Comments of the Vote Solar Initiative On Errors in the Draft E3 Net Energy Metering Study

Appendix A: Vote Solar Comments on Errors in E3 Net Energy Metering Study

Figure A1: Spreadsheet Error Shifting Capacity Values to One Hour Later

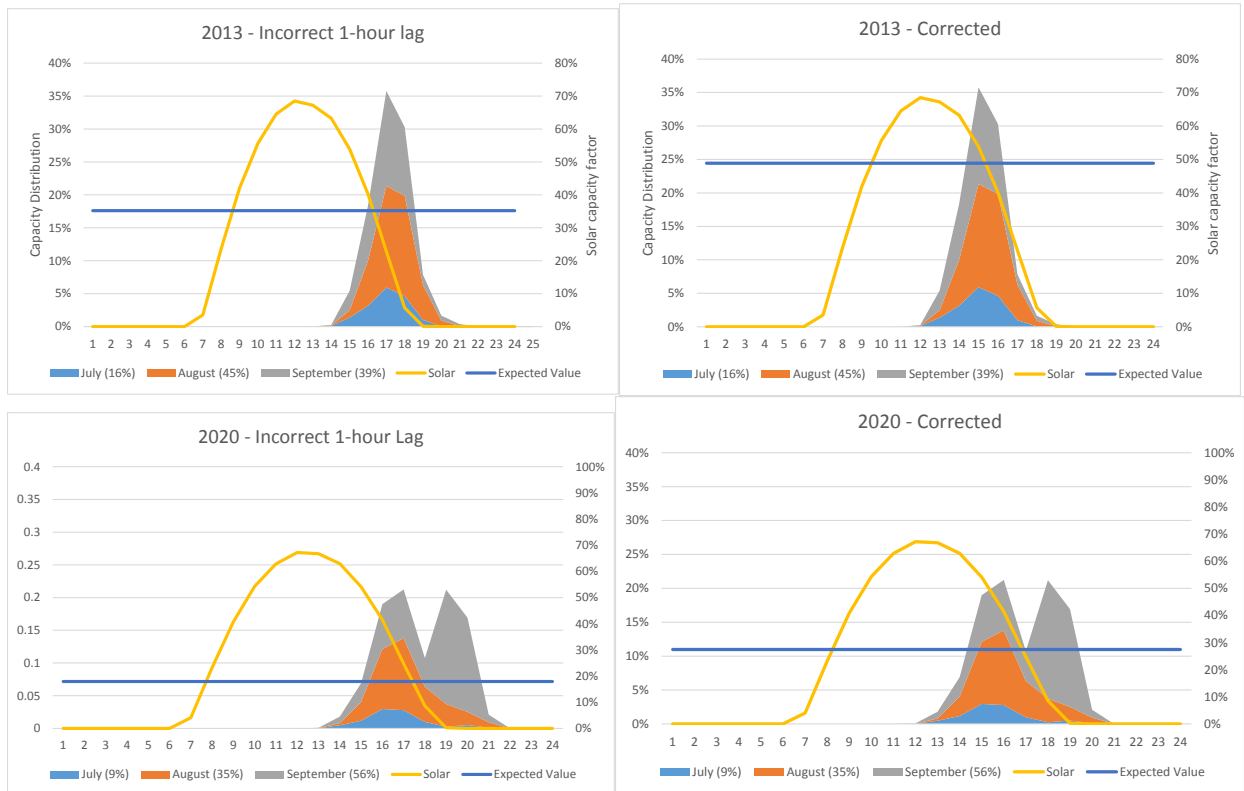
E3 made a spreadsheet error that shifts its generation capacity values one hour later into the afternoon. This has a significant impact in reducing solar's capacity value. We do not know whether the same error exists for the allocation of T&D capacity costs, as those are hard-wired numbers.

Column "AK" of the "Hourly Allocation" tab in the avoided cost model makes use of Excel's "Offset" function to gather the hourly capacity allocators from the "Capacity Allocation" tab of the model. However, the row offset variable in the function needs to be rounded to the nearest integer (i.e. hour) so that Excel does not look up the value for the preceding hour (for example, Excel will look up hour 1 when the variable equals 1.999999...). The problem can be fixed by changing the formula to ensure the correct hour is referenced, by rounding the "24 x (current datetime – start datetime)" term to the nearest integer. Thus, for example, the formula in Cell AK7 could be changed as indicated below:

This one-hour shift in the capacity allocation appears to be a significant error, and it incorrectly reduces the capacity value of solar PV. For example, in 2012 the model notes that the 2012 marginal solar ELCC is 49% (i.e. see cell G20 of the "Avoided RPS: tab."). We observe that fixing the lag problem identified above indeed results in a 2012 capacity-allocation-weighted average solar output equal to 49% (i.e. sumproduct of columns AH and AK in the hourly tab). Without the correction, however, the value is 35%. Thus, the model is incorrectly de-rating the ELCC for solar PV by almost 30% (0.35/0.49), due to this spreadsheet error.

For 2020 the results are even more extreme: the RPS tab indicates a 32% ELCC; however, the sumproduct of the solar output (column AH) and the allocators (column AK) is 18%. Thus, the advertised ELCC is 78% above the value actually used. The four figures in Figure A1 of the attached Appendix A provide two examples illustrating the problem with the incorrectly lagged allocation factors: solar PV output is less correlated with the most important "capacity allocation" hours if that allocation is incorrectly lagged one hour later in the day.

```
OFFSET('Capacity Allocation'!$D$2,ROUND((C27- $C$27)*24,1),MATCH(StartYear,'Capacity Allocation'!$D$1:$AU$1,0)-1)
```
